MARS/CAP Modification: IC-7200

RX Frequency Coverage Expansion

TX/RX Frequency expansion of IC-7200

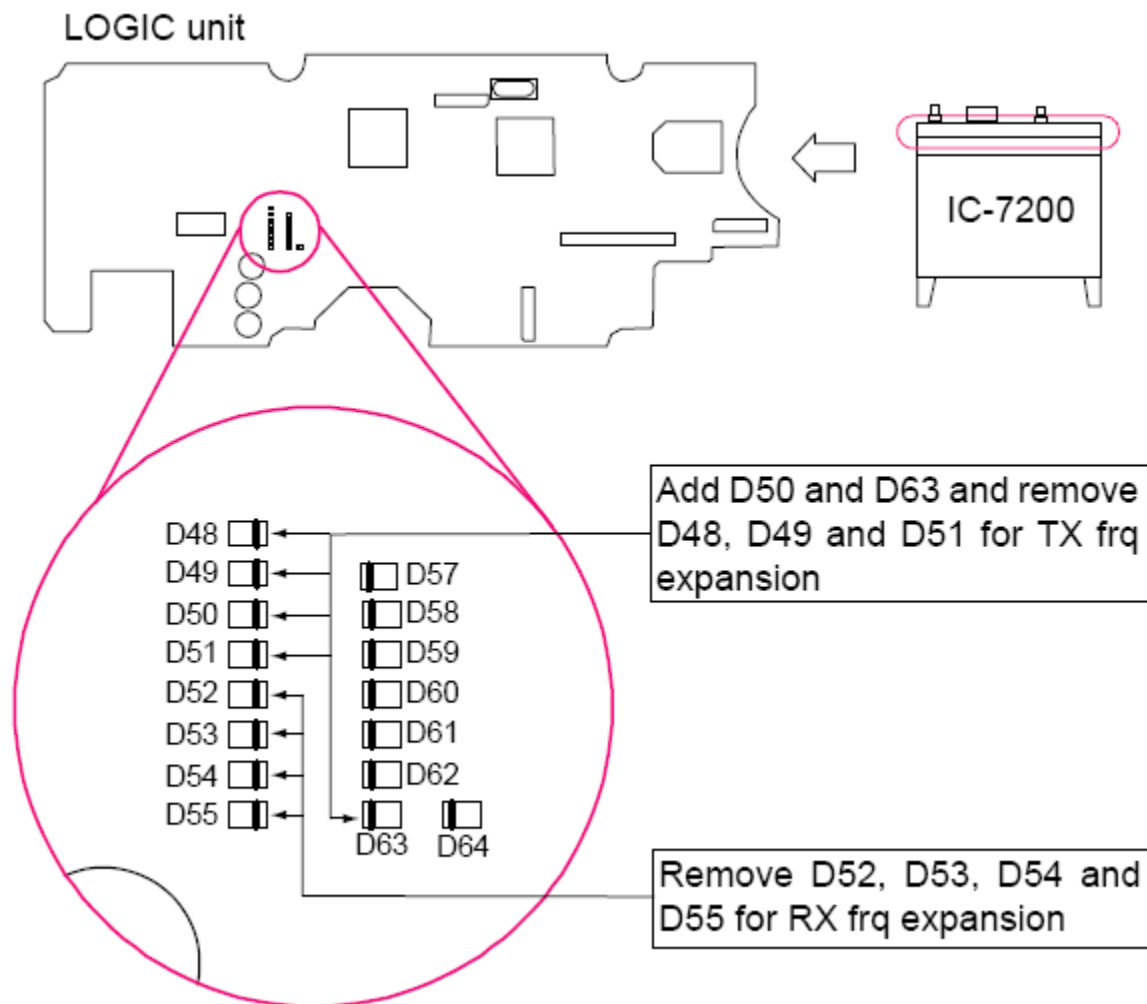
Remove D52, D53, D54 and D55 as shown below.

Add D50 and D63 and remove D48, D49 and D51 as shown below.

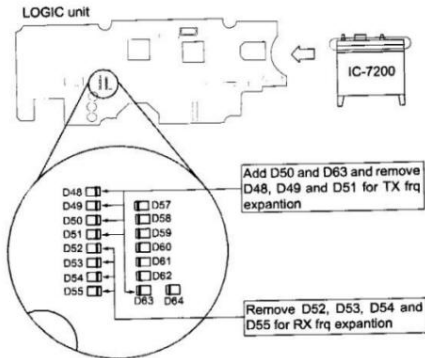
Remove D52, D53, D54 and D55 as shown below.

Add D50 and D63 and remove D48, D49 and D51 as shown below.
